From:
**Monks Orchard Residents' Association
Planning**

Reference:	20/03721/FUL
Application Received	Tue 18 Aug 2020
Application Validated	Tue 18 Aug 2020
Address	19 Orchard Avenue Croydon CR0 8UB
Proposal	Demolition of existing dwelling, erection of 9x flats, revised access, parking, landscaping and relocation of dropped kerb.
Status	Awaiting decision
Case Officer:	Christopher Grace
Consultation Expiry:	Thu 17 Sep 2020
Target Decision:	Tue 13 Oct 2020

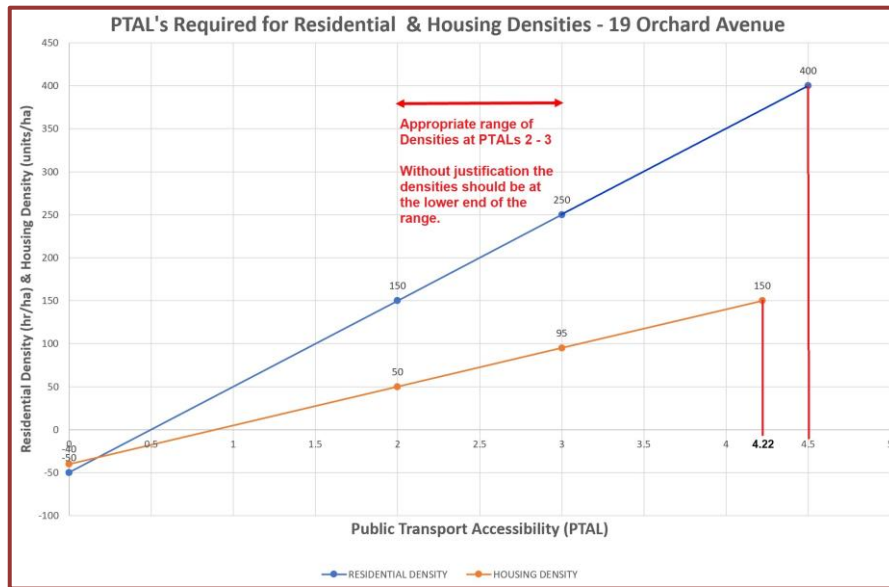
Thus, the PTAL required for Housing Density of **150 u/ha** is **4.22** when the actual PTAL is just **2**.

We object to this proposal on grounds of **significant overdevelopment** for the locality if classified as a “suburban setting” at Residential Density of **400 hr/ha** and Housing Density of **150 units/ha** at an average of **2.67hr/unit**. So, this proposed development is an **OVERDEVELOPMENT** for a **Suburban setting at PTAL 2** and forecast to remain at PTAL 2 until at least 2031. These Residential and Housing Densities are more appropriate to an “Urban” Setting as can be seen at Table 3.2 above (marked in RED).

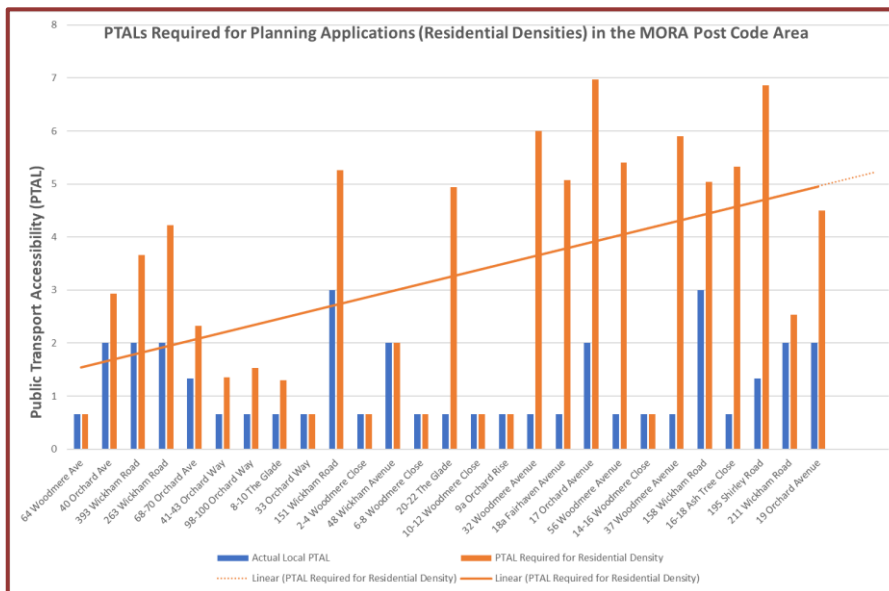
This Histogram shows the cumulative effect of recent in-fill and Redevelopments, Residential Densities and the actual required PTALs in the MORA Post Code Area showing the trending toward a PTAL of 6 (indicating significant cumulative over-developments for the available & planned Infrastructure).

This histogram also gives a clear indication of the **cumulative effect** of **NOT** implementing London Plan Policy 3.4 – Optimising Housing Potential, over recent years to the detriment of local residents as the area has now **“unsustainable access to Public Transport”**.

Figure 2.11c: Height of projection beyond the rear of neighbouring properties is no greater than 45 degrees as measured from the middle of the window of the closest habitable room on the rear of the neighbouring property.

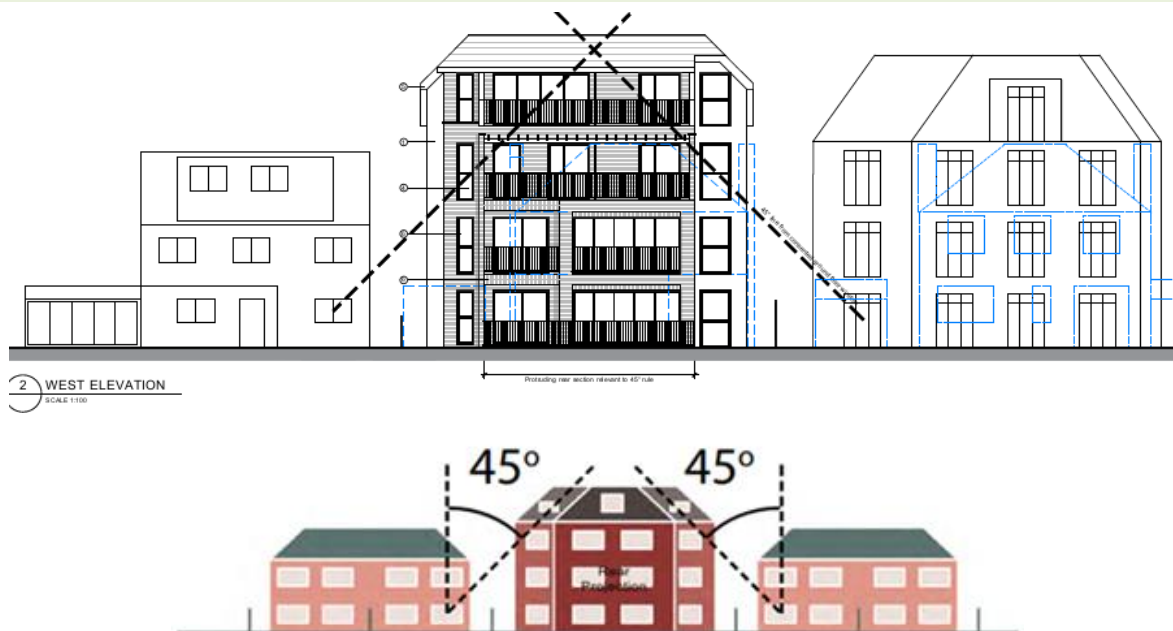
SPD2 Para 2.11 requires **Height of projection** of neighbouring properties should be no greater than the intersection of the projected line at 45° as measured from the Centre of the closest habitable room on the ground floor rear of the neighbouring property. We have used the adjacent provided rear elevations which **clearly establishes** that the projected **45° line** is **not clear** of the **proposed structure** and thus **fails the Policy by a significant degree**.

We object to this proposed development as it **clearly fails** to meet the **design guide** requirement of **SPD2 Chapter 2 – Suburban Residential Development** section **2.11c** which requires **clearance of the projected 45° Rule from the centre ground floor rear window of adjacent properties**. This proposed development significantly fails this **45° Rule** for both adjacent properties and **therefore this proposal should be refused**. This **45° Degree vertical rule** is totally independent of the daylight and sunlight requirements (as the policy indicates “also” in the definition which indicates the two policies are “mutually exclusive”).
